Report to Planning and Environment Committee

Subject: Parkit Enterprises
568 Second Street, Ward 3
File: Z-9522
Public Participation Meeting on

Date: June 19, 2023

Figure 4. Conceptual Site Plan (May 2022)

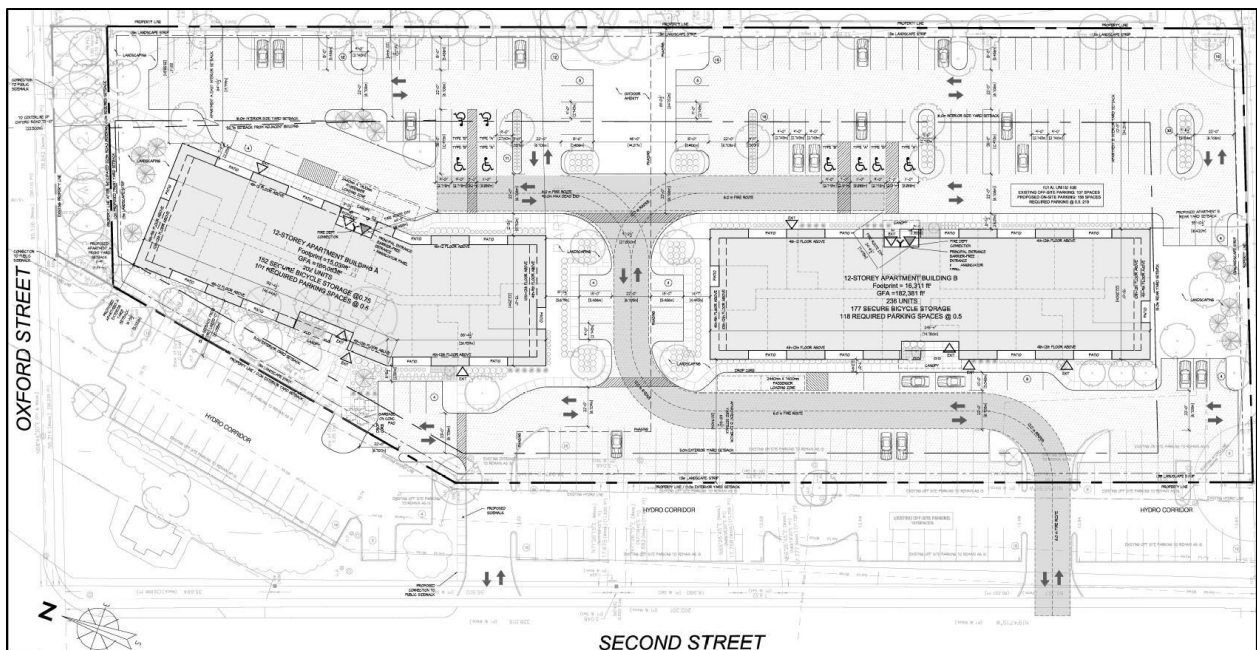
Concerns have been raised by City staff about the site design of the proposal, including the limited amount of amenity space and landscaped open space, the excessive amount of parking provided, the safety and connectivity of pedestrian circulation on site, and the impacts of the height and mass of the proposed buildings on the site and surrounding area. An alternative recommendation has been provided to ensure the future built form is in keeping with the policies of The London Plan. A special provision is being recommended to restrict the amount of surface parking to a maximum of 0.5 spaces per unit.

...Urban Design recommends that the applicant adjust the floor plate size of the proposed built forms above the 8th floor and screen the parking from Second Street (LP, 841.12). The trees planted to screen the surface parking along Oxford Street East are acknowledged. The development should also incorporate transit-oriented design principles (i.e., mixed-uses, transit and pedestrian amenities, enhanced streetscaping, transition in height of the proposed built-form from the intersection) (LP, 841.4 & 841.5).

- Provide a parking setback from the front and western side yard property boundary, to ensure that parking is setback and screened from Oxford Street East and Second Street.

- The location of the outdoor amenity spaces provided between two rows of parking is undesirable. Remove or relocate the parking adjacent to amenity areas to a different location.

- Reduce the amount of surface parking and explore opportunities to locate the parking underground or within a parking structure to mitigate the potential heat island effects and provide an efficient use of land and larger amenity areas.

- (c) The Site Plan Approval Authority **BE REQUESTED** to consider the following design issues through the site plan process:
- i) That any required amenity space be constructed as part of Phase 1 of the project;

- ii) Limit parking between the buildings and Second Street to one row of parking spaces on the subject site;
 - iii) Provide direct and convenient walkway access from the main building entrances to the public sidewalk;

Figure 6. Rendering looking East from Second Street (May 2023)

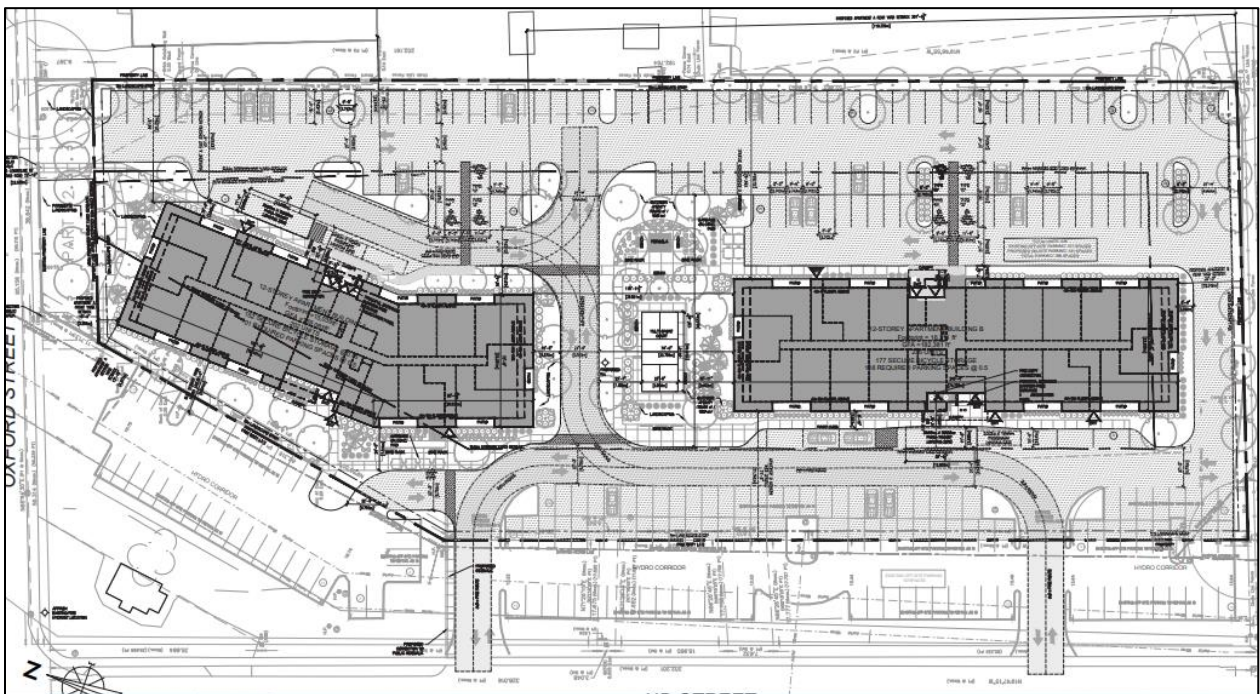
The applicant's have made three submissions in response to Urban Design Peer Review Panel (July 20, 2022) and internal staff comments (July 21, 2022, December 22, 2022 and April 4, 2023) (see detailed comments in Appendix B). Few changes have been made since the application was first submitted in May 2022. The latest Urban Design comments say;

Urban Design recommends that the applicant adjust the floor plate size of the proposed built forms above the 8th floor and screen the parking from Second Street (LP, 841.12). The trees planted to screen the surface parking along Oxford Street East are acknowledged. The development should also incorporate transit-oriented design principles (i.e., mixed-uses, transit and pedestrian amenities, enhanced streetscaping, transition in height of the proposed built-form from the intersection) (LP, 841.4 & 841.5).

To address these building design considerations, the staff recommendation is to add a maximum height of 39m (12 storeys) and to limit the floorplate above the 8th storey (floors 9 through 12) to a maximum of 1000m². Consideration of the Site Plan authority to increase landscape open space and screening of surface parking is also being recommended, along with a special provision to restrict the amount of surface parking to 0.5 spaces per unit.
